# UNITED STATES PATENT AND TRADEMARK OFFICE

| APPLICATION NO.                        | FILING DATE | FIRST NAMED INVENTOR | ATTORNEY DOCKET NO. | CONFIRMATION NO. |
|--|-------------|----------------------|---------------------|------------------|
| 10/764,908                             | 01/26/2004  | Fang Lei             | 02581- P0553A       | 3365             |

# Office Action Summary

## **DETAILED ACTION**

FIG.1

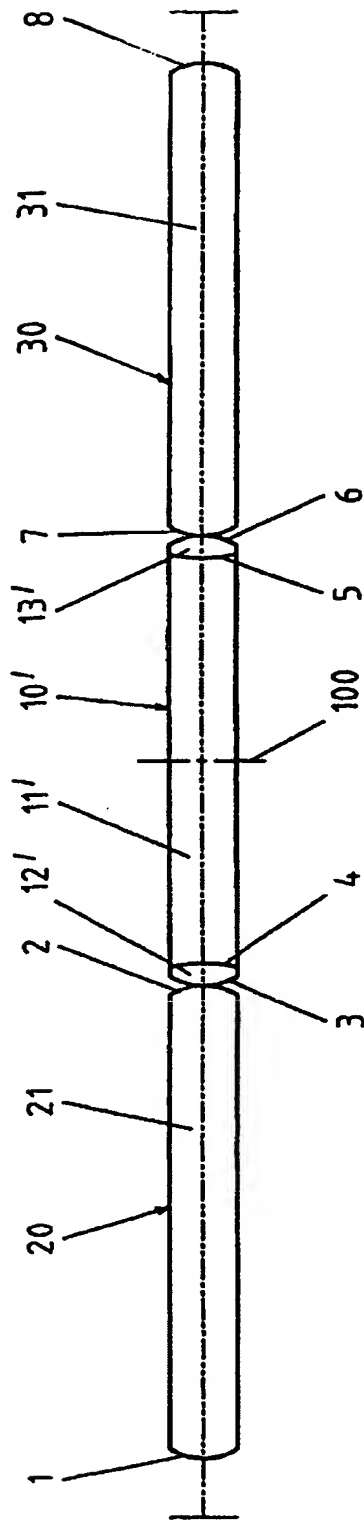
4. The drawings are objected to as failing to comply with 37 CFR 1.84(p)(5) because they include the following reference character(s) not mentioned in the

description: The numerical references "21" and "31" shown in figure 1 are not mentioned in the specification. Corrected drawing sheets in compliance with 37 CFR 1.121(d), or amendment to the specification to add the reference character(s) in the description in compliance with 37 CFR 1.121(b) are required in reply to the Office action to avoid abandonment of the application. Any amended replacement drawing sheet should include all of the figures appearing on the immediate prior version of the sheet, even if only one figure is being amended. Each drawing sheet submitted after the filing date of an application must be labeled in the top margin as either "Replacement Sheet" or "New Sheet" pursuant to 37 CFR 1.121(d). If the changes are not accepted by the examiner, the applicant will be notified and informed of any required corrective action in the next Office action. The objection to the drawings will not be held in abeyance.

*It is noted that in the amendment, page 14, the second paragraph, applicant has stated that the references "21" and "31" have been removed; however, such references are still shown in figure 1 of the corrected drawings filed on 7/18/05.*
